DOW CHEMICAL TRIGA
RESEARCH REACTOR
LICENSE NO. R-108
DOCKET NO. 50-264

REVISED SAFETY ANALYSIS REPORT,
TECHNICAL SPECIFICATIONS, AND
RAI RESPONSES (2/11/2011)

Subject: Dow Chemical Company- Response to the Request for Additional Information for the renewed license of the TRIGA research reactor. License No. R-108; Docket No. 50-264

Response to the request for additional information
The Dow Chemical Company
February 2011

Figure 4. Upper grid

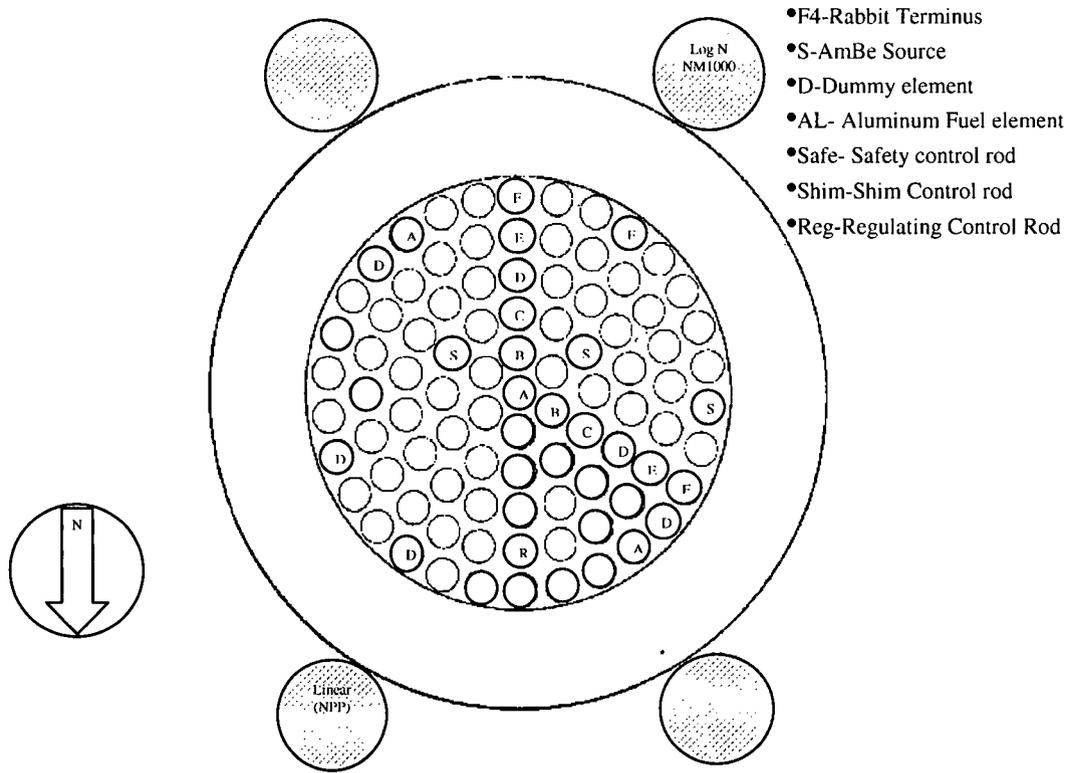
11. NUREG–1537, Part 1, Section 4.2.5, “Core Support Structure” requests the applicant to provide design information pertaining to the core support structure. DTRR SAR, Chapter D, does not provide sufficient information. Please provide figures depicting the upper and lower core plates and provide the dimensions and locations of all penetrations that allow coolant to flow through them.

Two aluminum grid plates fix the position of fuel elements, dummy elements and neutron source. Figure 4 is the schematic drawing of the upper grid plate with the position of the control rods, pneumatic transfer location and source indicated. The upper plate is 3/4 inch aluminum and 1.5 inch diameter holes to position the fuel, dummy elements, control rods, etc. The bottom plate is 3/4 inch aluminum and has holes to receive the end pins of the fuel and dummy elements. Thirty-six holes for the natural convection cooling are found on the lower grid plate. The water passes through the upper grid plate by means of the gap between the triflute section of the fuel and the upper grid plate. The penetrations on the lower grid plate are in concentric rings with 7, 12, and 17 holes, respectively. Figure 5 is a photograph of the lower grid plate. This photograph substantiates the as built drawings given by General Atomics, and previous Safety Analysis Reports submitted by The Dow Chemical Company. Figure 5 is a photograph of the lower grid plate.

Figure 6. Block Diagram Cooling System
A, B, C, and D are valves that can be used for isolation

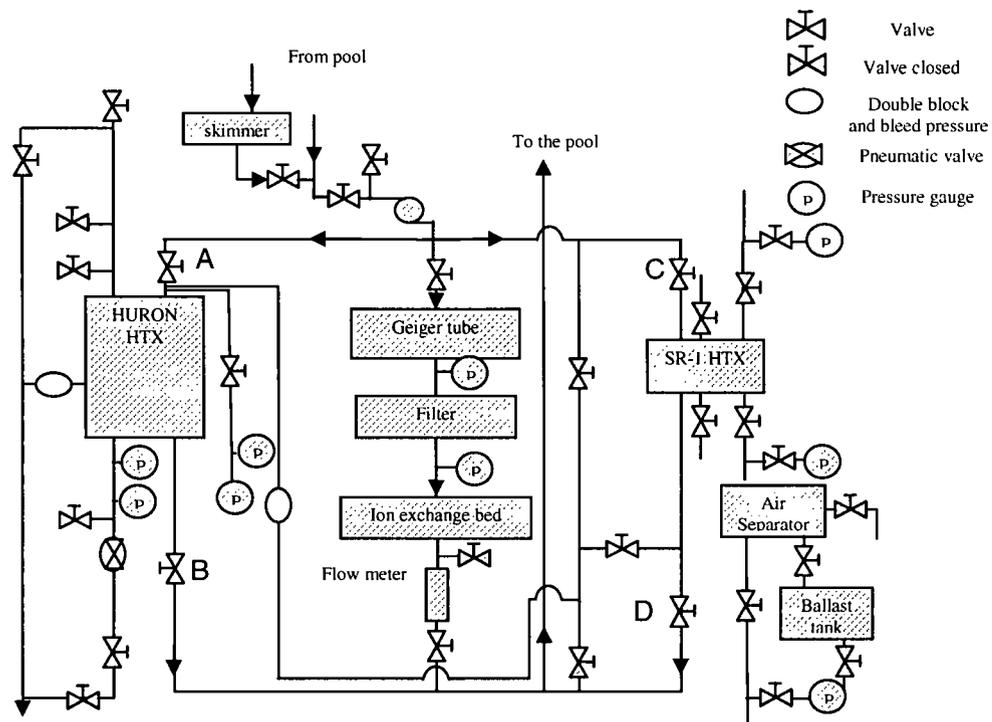
23. NUREG-1537, Part 1, Section 5.3, "Secondary Coolant System" requests the applicant to provide a description of the secondary coolant system, including schematics and flow diagrams for the secondary coolant system.
- 23.1 DTRR SAR, Section E.1, states that "the heat rejection systems can be operated independently or in tandem." DTRR SAR, Section E.1, Figure 6, Reactor Coolant System, shows no valve arrangement that

accomplishes these functions. Please provide schematics and flow diagrams for the secondary system, including valves, which show how the secondary coolant system can be operated independently or in tandem.

23.2 DTRR SAR, Section E.1, does not provide sufficient information describing the secondary system. Please provide a more detailed description of the secondary coolant system and describe how primary to secondary leakage would be detected.

23.2 Figure 6 is of the heat exchange system installed at the DTRR. The reactor is cooled by natural convection. Thus, the system is not required for operation.

Figure 7. Detector ranges

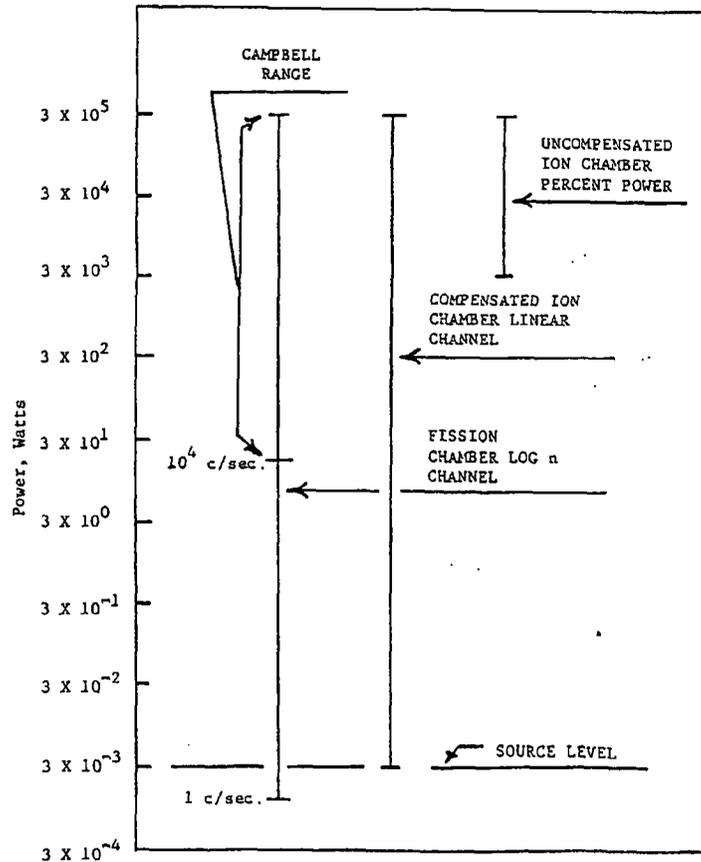
30. NUREG–1537, Part 1, Section 7.3, “Reactor Control Systems (RCS)” requests the applicant to provide information regarding the functions of the RCS. DTRR SAR, Chapter G, does not provide sufficient information.

monitors for the DTRR. The combined range of the two instruments covers from 3×10^{-4} up to 3×10^5 Watts. Figure 7 is the range of the two instruments.

Figure 9. Block Diagram of the console

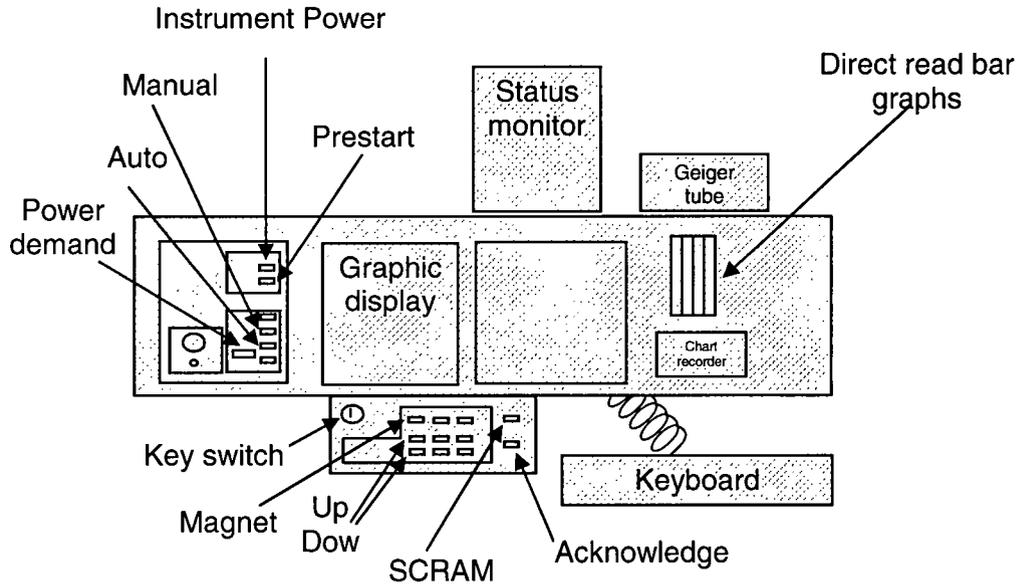
32. NUREG-1537, Part 1, Section 7.6, "Control Console and Display Instruments" requests the applicant to provide a complete description of all console functions, as they relate to the proper operation and shutdown of the reactor. DTRR SAR, Chapter G, does not provide sufficient information.
- 32.1. Please describe the console controls and operator interfaces.
- 32.2. Please describe the location of the instruments and how the locations relate to the reactor and other system controls in the main console and auxiliary control room racks.
- 32.3 Please provide drawings or photographs showing the arrangement of the display instruments and console control equipment.

32.3 Figure 9 is a block diagram of the console.

Figure 11. HVAC for the DTRR reactor room.

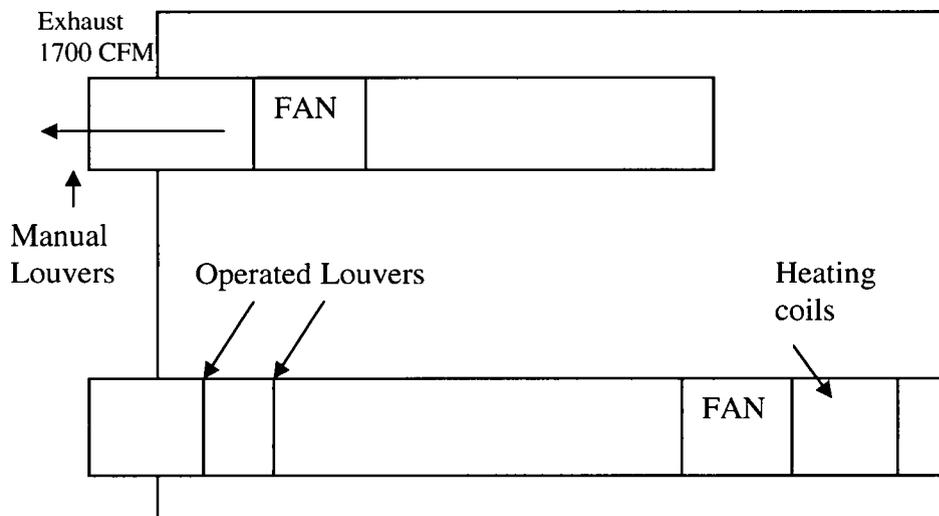
34. NUREG-1537, Part 1, Section 9.1, "Heating, Ventilation and Air Conditioning System" requests the applicant to provide a description of the heating, ventilation and air conditioning system (HVAC) and any manual or automatic functions. There is a brief description in DTRR SAR I.1 regarding this function with no schematics or illustrations. Please provide a more detailed description of the HVAC system and system functions and provide schematics of the HVAC system.

The HVAC for DTRR is Figure 11. The inlet to the reactor room is located to the north side of the reactor room. The outlet is located on the east wall of the building. The ventilation system inlet is equipped with a set of louvers that can be shut from the control room by the operator if necessary to isolate the reactor room. The exhaust is also equipped with a set of louvers that can be shut manually from the exterior of the building. The fume hood exhausts are separate from the HVAC system.

Figure 6.1. Administration

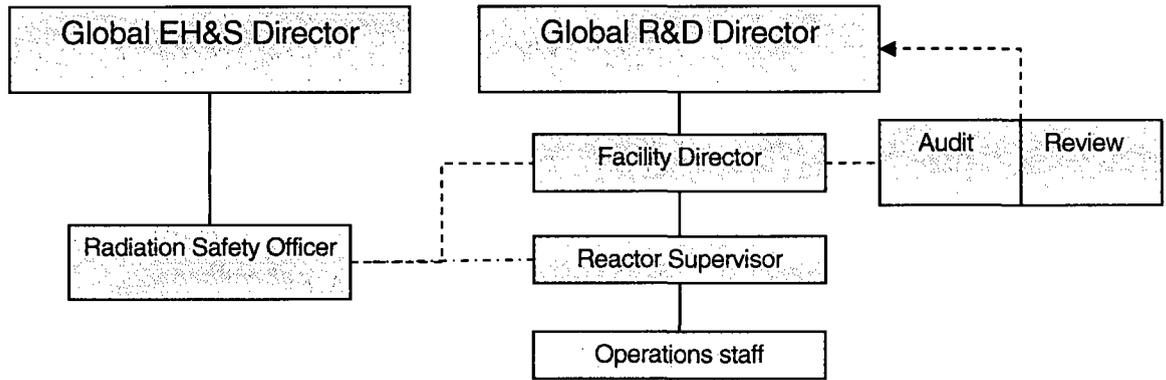
- 65.1 ANSI/ANS-15.1-2007, Section 6.1, “Organization” recommends organizational structures including levels and reporting authority. DTRR TS Figure 6.1, the DTRR organization structure, includes no level 3 or 4 staff and differs from Figure 8.0 of the DTRR SAR.

65.1. Figure 8 of the SAR is the reporting structure for the reactor operations staff and does not include the reporting structure for the Radiation Safety Officer. Figure 6.1 of the TS has been changed to comply with ANSI/ANS-15.1. Figure 6.1 includes the chain of command for the Radiation Safety Officer.
